Proposed Boat Pump-Out BMP

Wastewater Workgroup
November 6, 2018

U.S. EPA Chesapeake Bay Program Office
Annapolis, MD

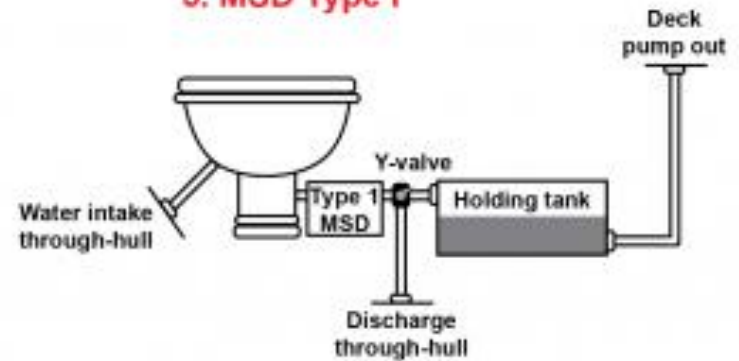
How to account for this as a credit in a “No-Discharge Zone” where these discharges are illegal.

Considering the concerns on specific calculations regarding the number of boats, those with MSD's capable of being pumped, nutrient values, and other calculated factors that impact the estimated loadings and benefits.with the lack of sufficient information on tracking and verification it does not seem warranted to include boat pump-outs as a simulated BMP. Also, considering the relatively small loadings there does not seem adequate justification ...to expend resources in the effort needed to adequately provide verifiable BMP reporting data to CBP considering the complexity of NEIEN and significant burden to provide adequate verification.

Response: This is a key point. Because of this concern and others, the proposed boat pump-out BMP is now limited to the marine sanitation devices (MSDs) of Type I and Type II flow-through discharges, but only in areas of the Chesapeake designated as no-discharge zones that meet specific record keeping requirements at boat pump-out facilities. For details on MSD types please see: https://en.wikipedia.org/wiki/Marine_sanitation_device

Response: Because of the difficulties and limitations in quantification listed above, Type III MSDs are no longer considered to be a nutrient reduction BMP under consideration by this report.
